Subject: Duke Energy Corporation  
Oconee Nuclear Station - Units 1, 2, and 3  
Docket Nos. 50-269, 50-270, and 50-287

Revisions to Topical Report DPC-NE-3003 In Support of  
Steam Generator Replacement  
Response to NRC Staff Request for Additional  
Information

Enclosed herein, please find the Duke Energy Corporation (Duke) response to the May 12, 2003 NRC staff's request for additional information concerning topical report DPC-NE-3003, Revision 1, "Mass and Energy Release and Containment Response Methodology."

### **Duke Power Response To Request For Additional Information**

(14.1 ft<sup>2</sup> Break - RV Outlet - High Initial RCS Flow w/ M3 Pump Degradation Model)

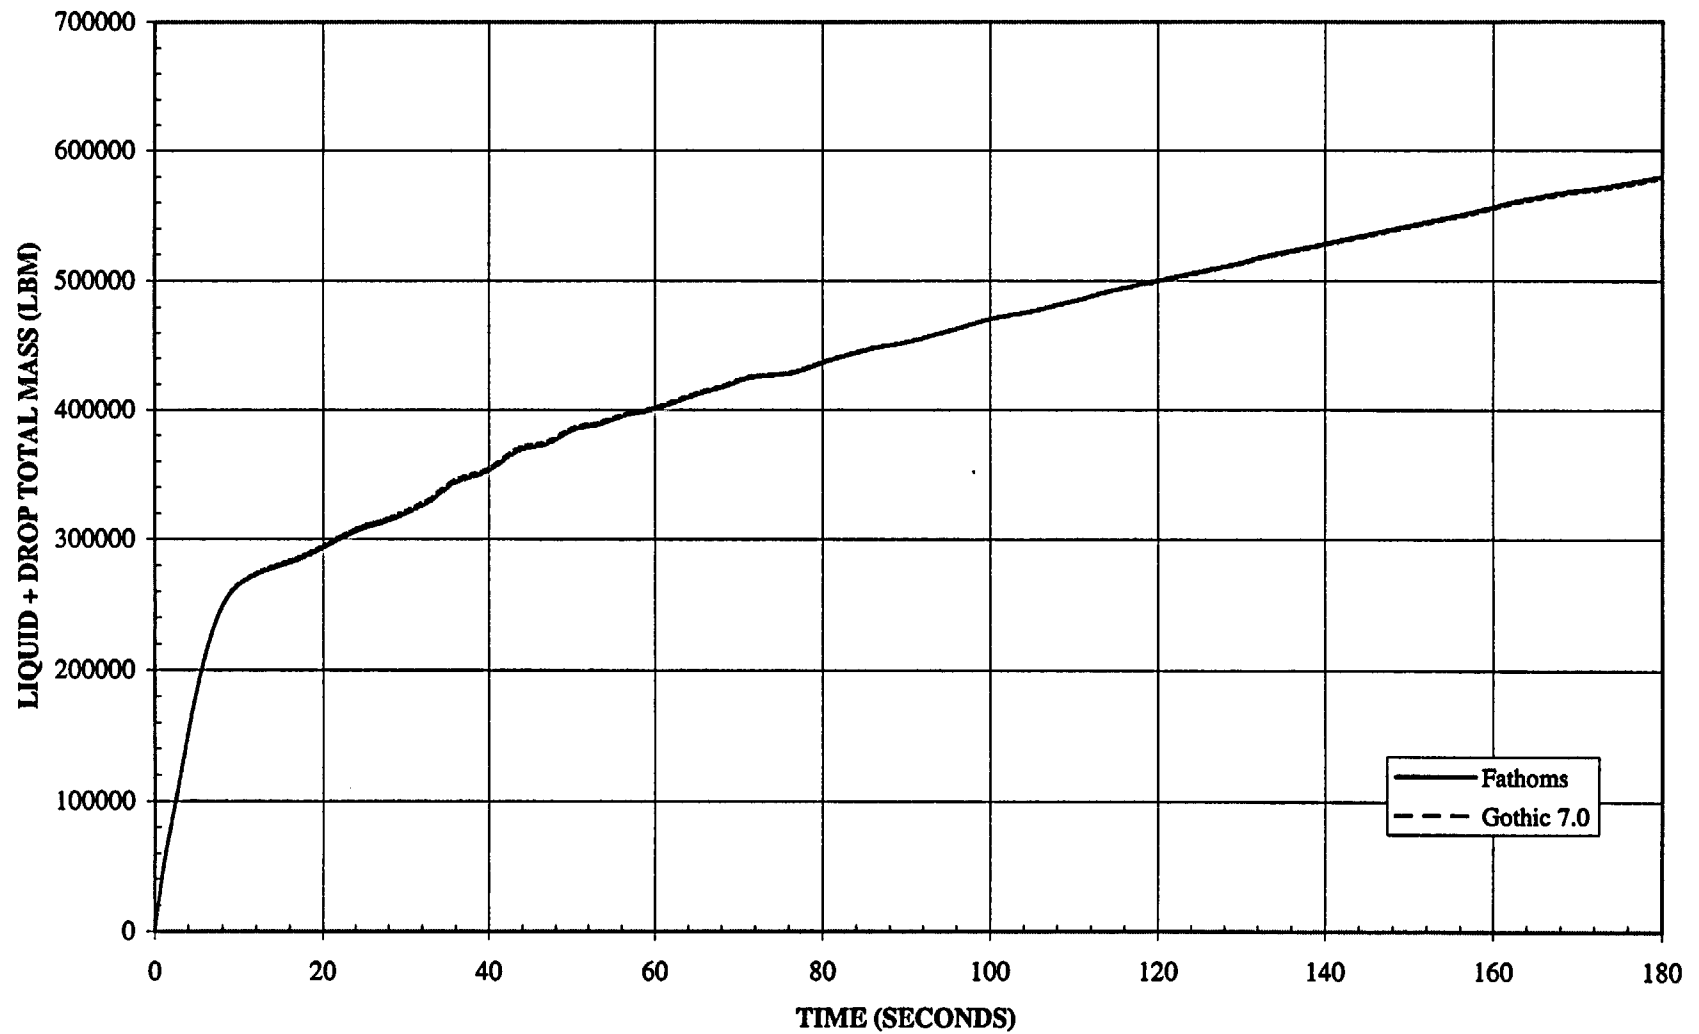
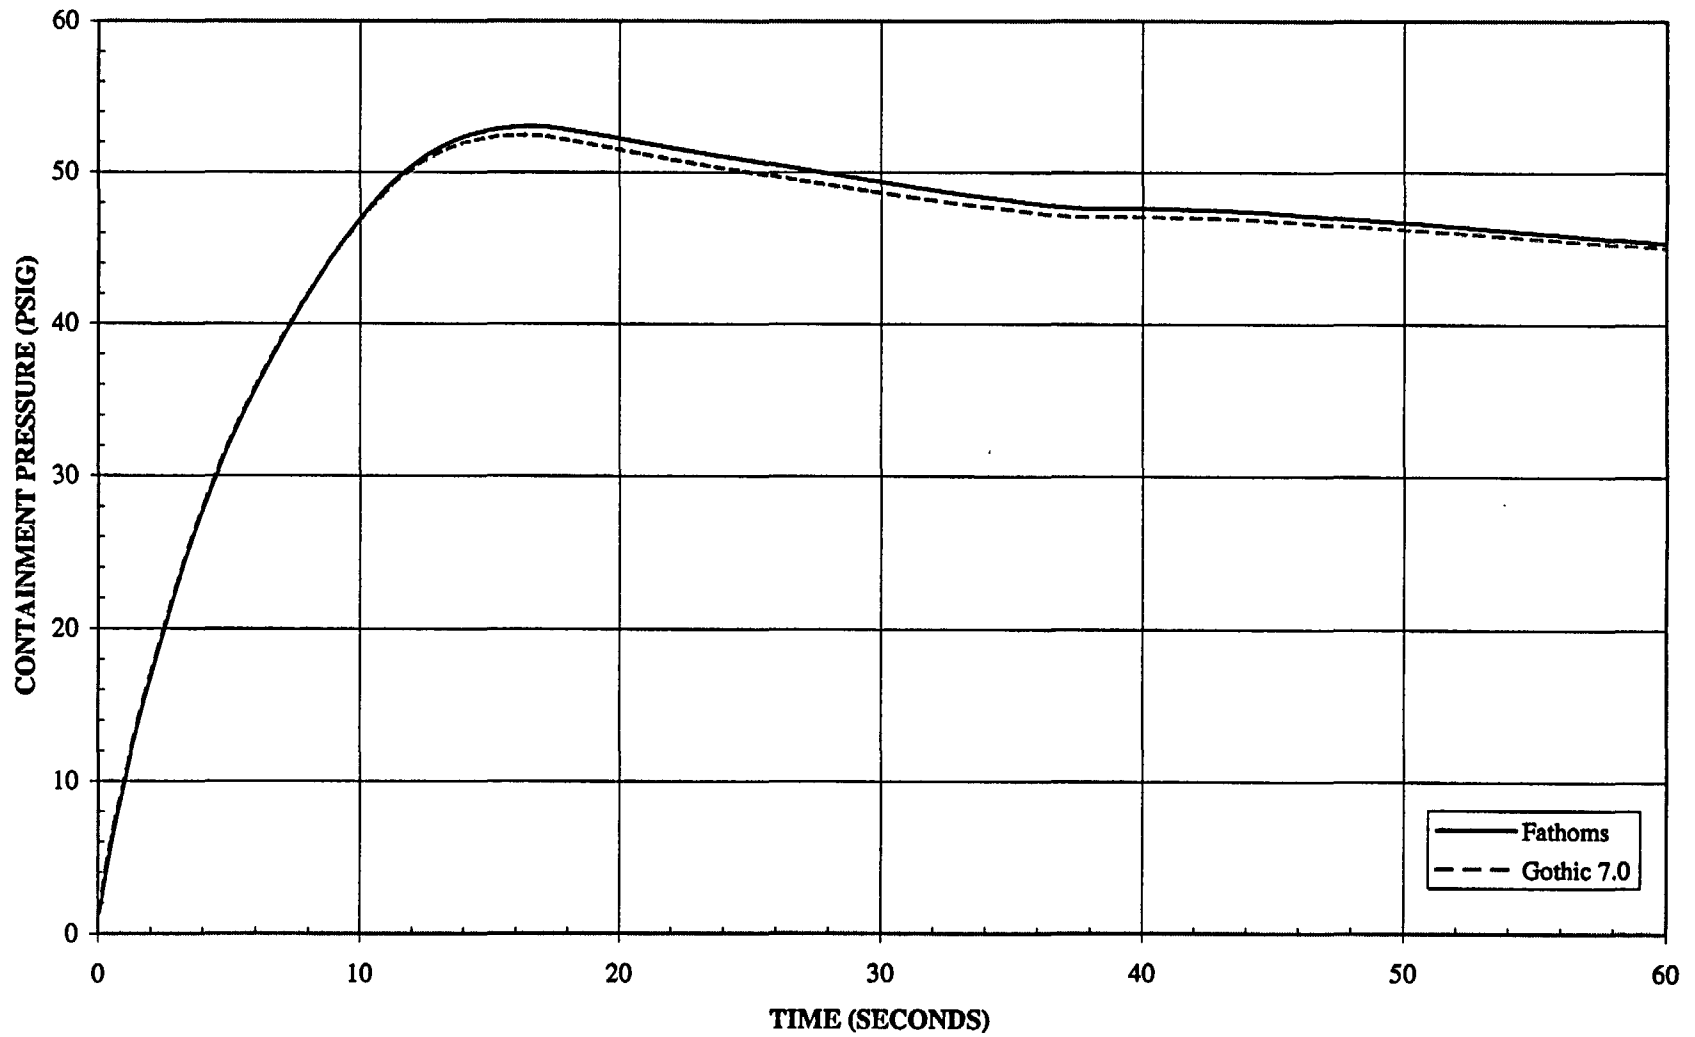
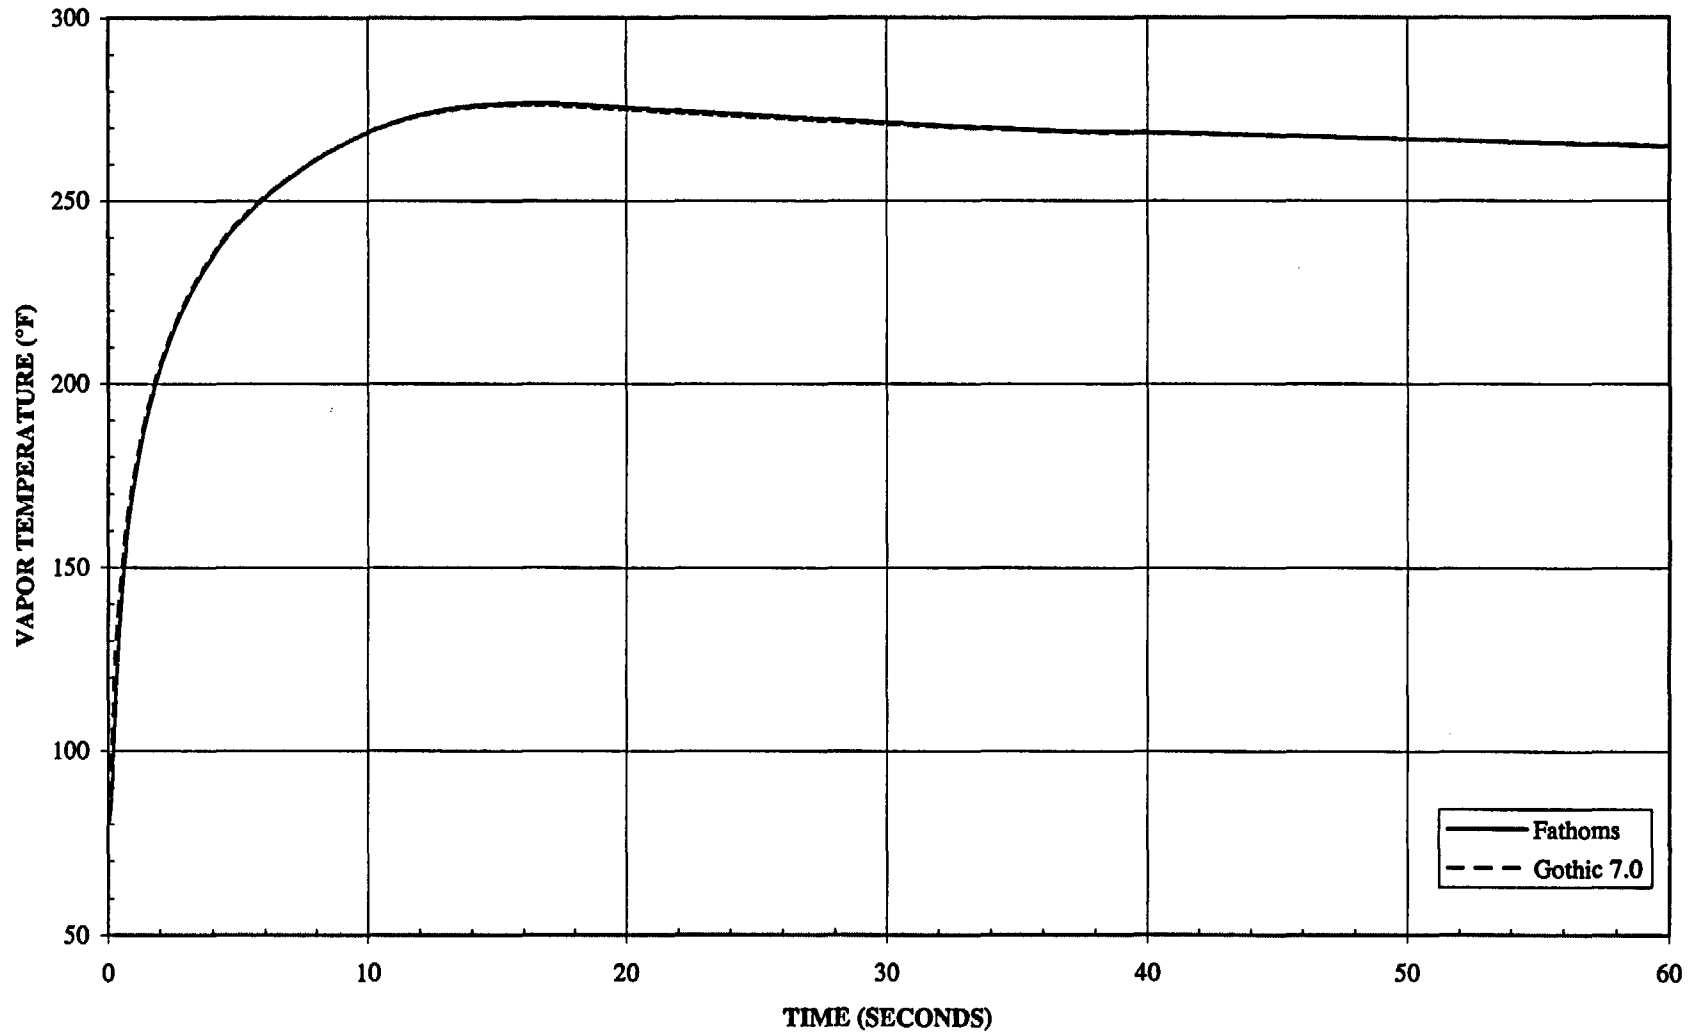
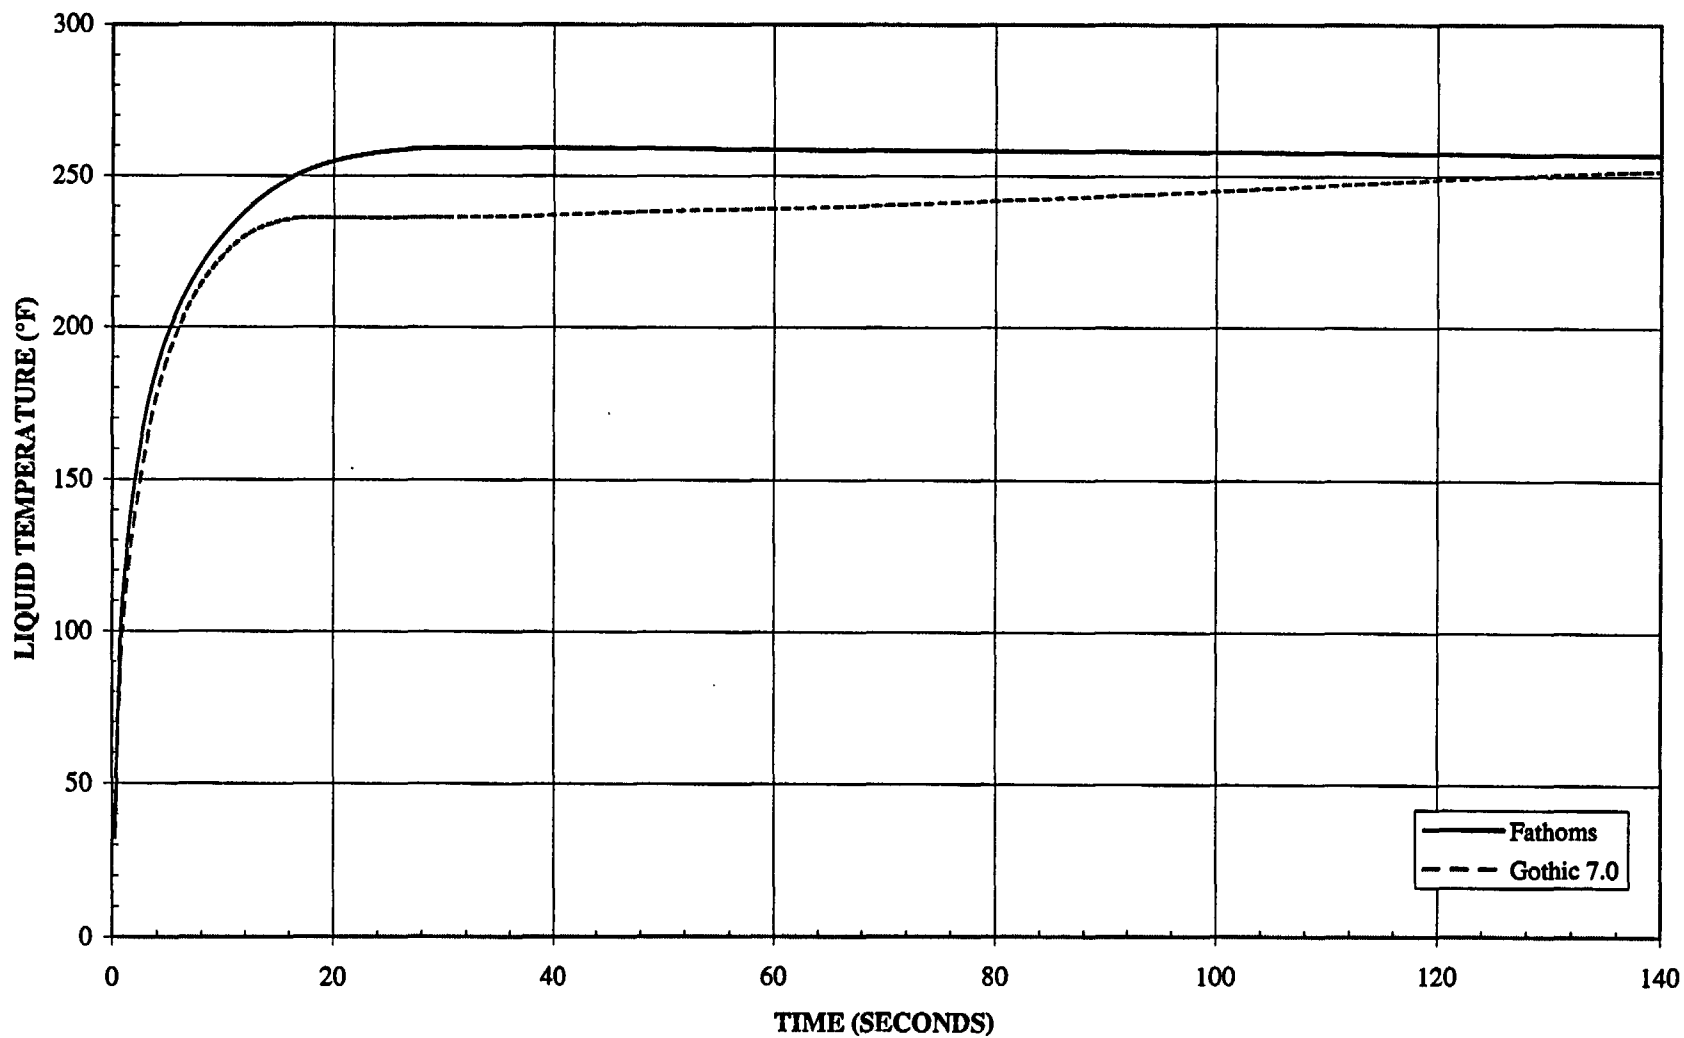
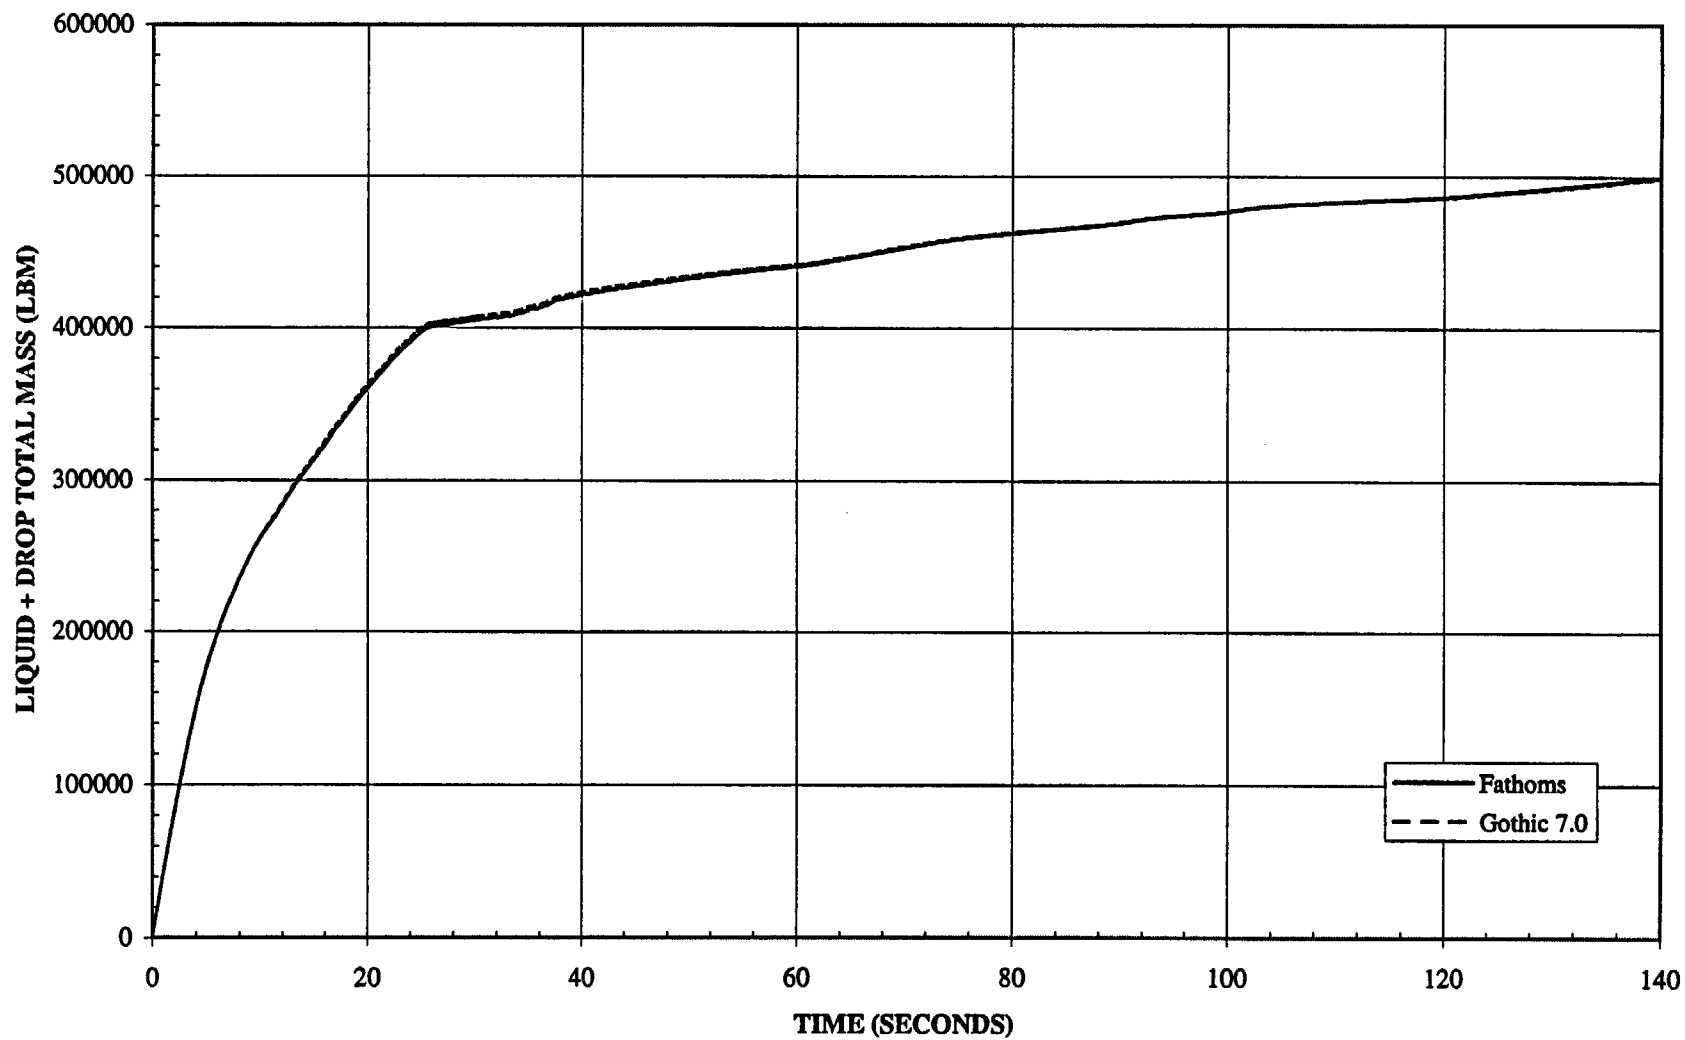
3. Please provide the results using the GOTHIC 7.0 code of peak pressure and temperature calculations for the sensitivity cases listed in Table 3.1-1 of DPC-NE-3003 in tabular and graphical form. If the results or conclusions are significantly different from those presented in DPC-NE-3003P, explain the difference.

Response: Table 3.1-1 of DPC-NE-3003 describes a spectrum of LOCA peak pressure cases including a range of break locations and sensitivity analyses for several important modeling assumptions. The staff's request is understood to focus on the difference in the predicted results from the FATHOMS and GOTHIC 7.0 code versions. Rather than show the comparison for the cases in Table 3.1-1, a different set of cases has been selected which is more focused on the current knowledge of the key sensitivity parameters. Also, the results presented are for the ROTSGs, which is the subject of Revision 1 to the topical report.

The results of the 14 code comparison analyses are shown in Table 3-1 below and in the figures that follow. In general, the pressure and vapor temperature response predictions were very similar in both magnitude and trend. GOTHIC 7.0 predictions for peak pressures and vapor temperature were slightly lower (~0.5 psig and 0.5°F). These differences are consistent with the code model differences described in the response to Question #1. Both codes predict a saturated containment atmosphere due to the large amount of drops injected. The slightly lower pressure, vapor temperature, and liquid temperature from GOTHIC 7.0 may be attributed to additional drop hold up in the atmosphere. This effectively increases the heat capacity of the atmosphere and reduces the temperature rise for a given energy addition. A comparison of the total liquid and drop masses, and liquid temperatures, show the predictions of the two codes to be essentially the same. This is consistent with the changes in the drop deposition and entrainment models discussed in Question #1. These results show that the two code versions give essentially similar results for the same break location and initial and boundary conditions.
